Work Order ID 86168

Item Name: Replacement Skidtube

DRAWING NO. D2580	TITLE 205 SKIDTUBE ASSEMBLY	REV. E	DART AEROSPACE LTD ENGINEERING ORDER	D.E.O. NO. D2580-E-1	SHEET NO. SHEET 1 OF 1	SCALE NTS
DRAWN <i>UP</i>	CHECKED <i>ASS</i>	MFG. APPR. <i>ER</i>	APPROVED <i>[Signature]</i>	DE APPR. <i>[Signature]</i>		
DATE 11.12.13	DATE 11.12.13	DATE 11.12.13	DATE 11.12.13	DATE 11.12.13	DATE 11.12.13

CHANGE ALL C'BORED WELDED CROSSBOLT SPACERS TO SWAGED SPACERS

SECTION B-B, F-F, I-I
NOT TO SCALE

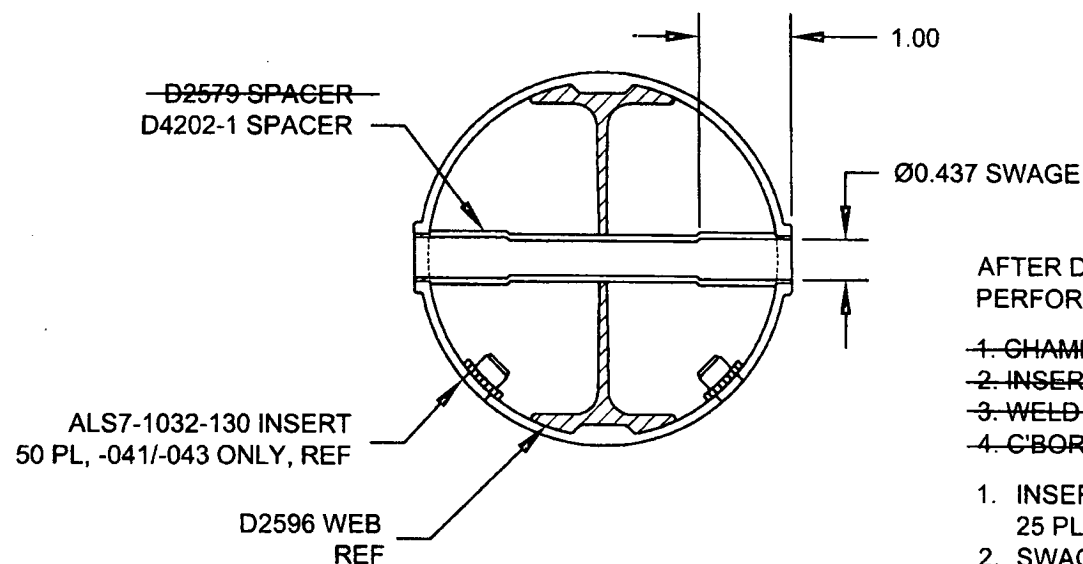
SECTION B-B, SECTION F-F, & SECTION I-I ARE AMENDED AS FOLLOWS
FOR ALL HOLES THAT WERE ORIGINALLY C'BORED:

- ~~1. CHAMFER HOLE 0.050 X 45°~~
- ~~2. INSERT D2579 SPACER (20 PLACES)~~
- ~~3. WELD INTO PLACE AND GRIND FLUSH~~
- ~~4. C'BORE D2579 SPACER TO Ø0.437 X 1.00 DEEP~~

WELD 4X D2579 SPACERS PER DWG
IN LOCATIONS MARKED "NO C'BORE".
REF SHEET 4 OF DWG.

1. INSERT D4202-1 SPACER, 20 PL (-041) OR 20 PL (-045) OR 25 PL (-047)
2. SWAGE TO Ø0.437 X 1.00 DEEP PER QSI 002
3. TRIM / GRIND FLUSH PER QSI 002
